In the Matter of)
LONG ISLAND LIGHTING COMPANY)
(Shoreham Nuclear Power Station,)
Unit 1))

TESTIMONY OF G. DENNIS ELEY, C. JOHN SMITH, GREGORY C.
MINOR AND DALE G. BRIDENBAUGH ON BEHALF OF SUFFOLK COUNTY
REGARDING EMD DIESEL GENERATORS AND 20 MW GAS TURBINE

ATTACHMENT 4 SCALE DRAWING OF EMD CONFIGURATION AND FUEL PIPELINE

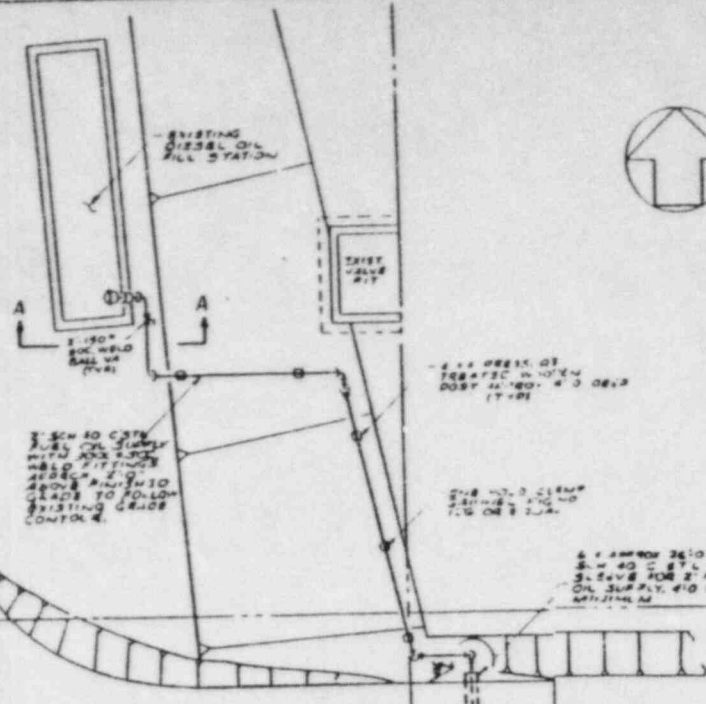
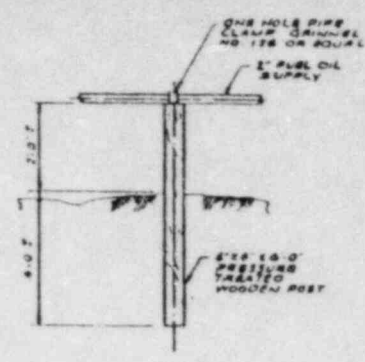
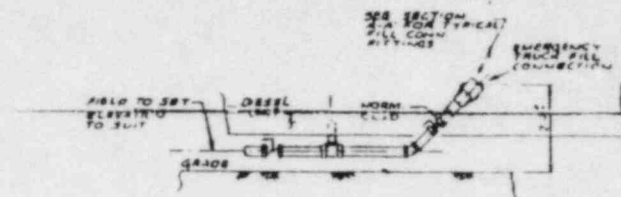
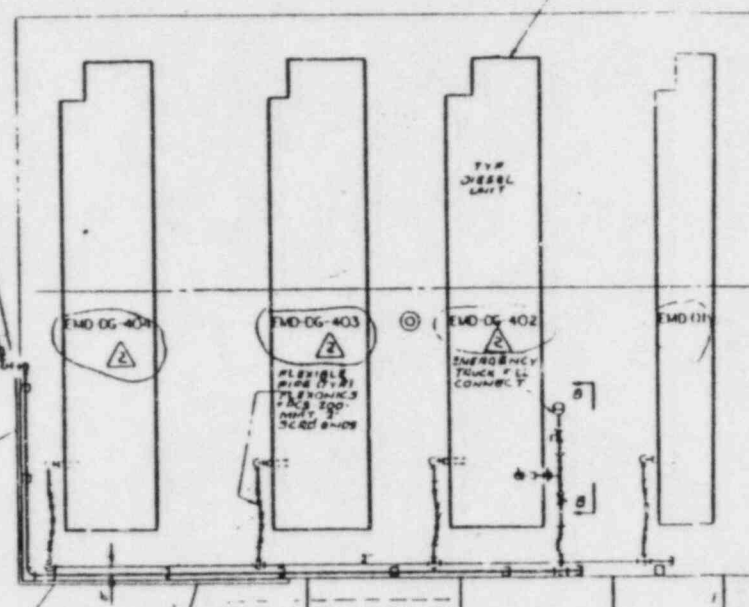
First, fuel for the EMDs is transferred from the tank truck into the supply line through a hose running from the truck. This hose apparently just lies on the ground as it runs from the tank truck to the connection with the supply line. (See Attachment 7.) The area in which the tank truck and hose

Second, the single supply line that carries fuel from the hose to EMD 402 is susceptible to failure due to both ground motion and missile impact. As other witnesses for Suffolk County have testified, a seismic event with ground acceleration of 0.2g's could cause the pipeline to rupture. (See Testimony of Dr. Christian Meyer, Dr. Jose Roesset and Gregory C. Minor on Behalf of Suffolk County.) The supply line is also susceptible to damage from missile impact. For example, at the point at which the pipe issues from under the south side of the ramp (See Attachment 4) there is no protection from the possibility of a vehicle, such as an articulated truck, striking and rupturing the pipe. Again because fuel for all four EMDs flows through this pipeline, damage to it would interrupt the flow of fuel from the tank truck to all the EMDs.

ATTACHMENT 5 - Schematic Drawing of EMD Fuel Supply System

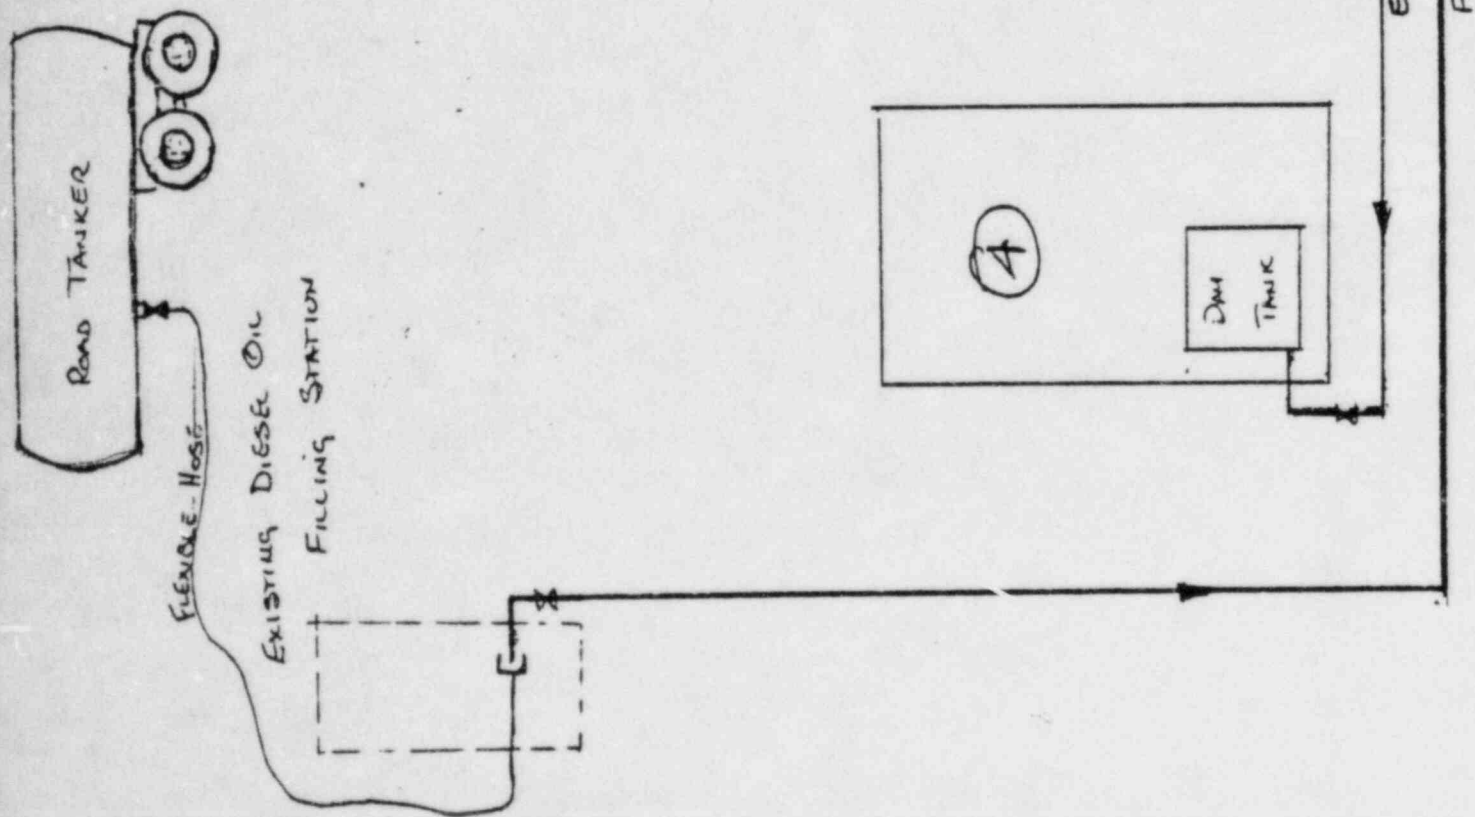
A. The fuel system for the EMDs presents another single failure vulnerability that is absent from the qualified emergency AC power source described in the FSAR, and as a result, the EMDs are less reliable than qualified AC power sources. In the case of qualified generators, if a failure rendered a fuel supply system inoperable, because each qualified generator has an independent fuel supply system, only one of the three generators would be affected; the other two generators could

For example, because all the fuel for all the EMDs flows through the pumps and day tank in EMD 402, an interruption of the fuel supply in that unit would interrupt the flow of fuel to all four EMDs. Thus, if a fire occurred in EMD 402, or if the pumps or float switches in EMD 402 failed, fuel would not be transferred from the single supply pipe to the day tanks of any of the EMDs. Similarly, because all the day tanks are interconnected by the equalizing line, any single failure, such as a rupture due to a seismic event, could adversely affect all four EMDs.
